**Urgent Field Safety Notice**  
**Programmer Software Update**  
**Supporting the Micra™ Transcatheter Pacing System**

Model
2090 CareLink™ Programmer 29901 Encore™ Programmer CareLink Network Application Software 2491

January 2019

Medtronic reference: FA856

Image 1

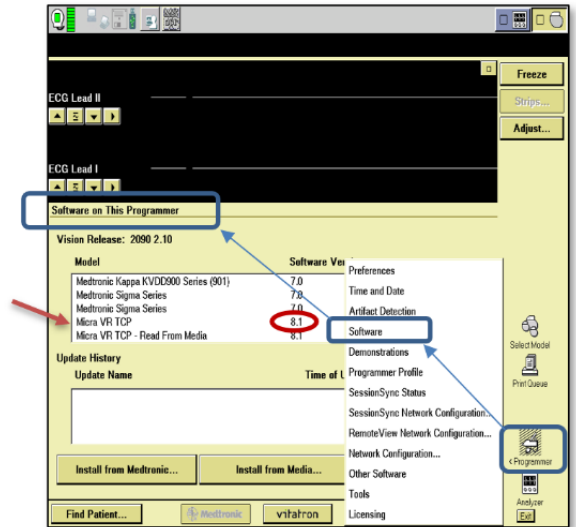
- Select Software (see image 1)
- Scroll through the list of available Software Models in the top selection box until you locate the Micra selection
- Verify the Software Micra VR TCP Version is 8.1

Correct software: Micra VR TCP version 8.1 (or higher)
